Re: 232nd Street, 132nd Ave. to Silver Valley Road conceptual design

Our Maple Ridge/Pitt Meadows HUB Committee is happy to support in principle the recommended option as shown on the display boards at the Open House on November 30, with the following suggested changes/comments:

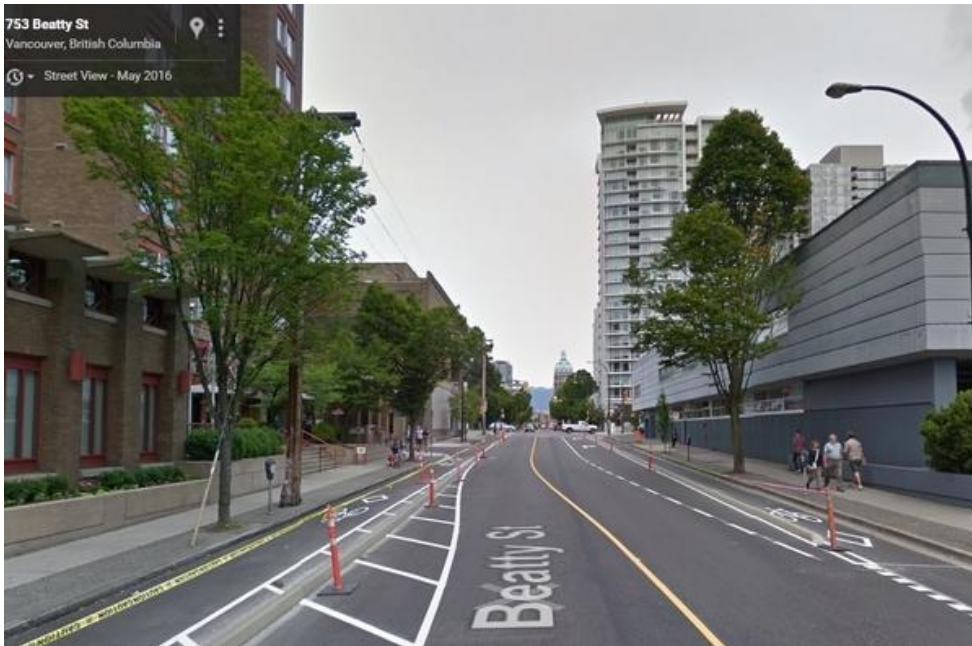
- Reduce the width of the motor vehicle lanes to 11 feet (3.35 m), as recommended in the [NACTO Urban Street Design Guide](#) for transit/truck routes. A reduction to the narrowest possible width for trucks and busses may have some positive effect on vehicle speeds on this section of 232nd Street.
- This reduction in motor vehicle lane widths means that the bike lane on the west side could be widened by 30 cm. This should improve safety when one cyclist passes another, especially at higher speeds due to the downhill nature of the bike lane.
- Our HUB committee proposes to add a cast in place curb to the bike lane on the west side, in order to prevent cars from parking on the bike lane. By placing the curb closer to the car lane than the bike lane, adequate width for safe passing can be ensured. Here is an example of cast in place curbs at Beatty Street in Vancouver:
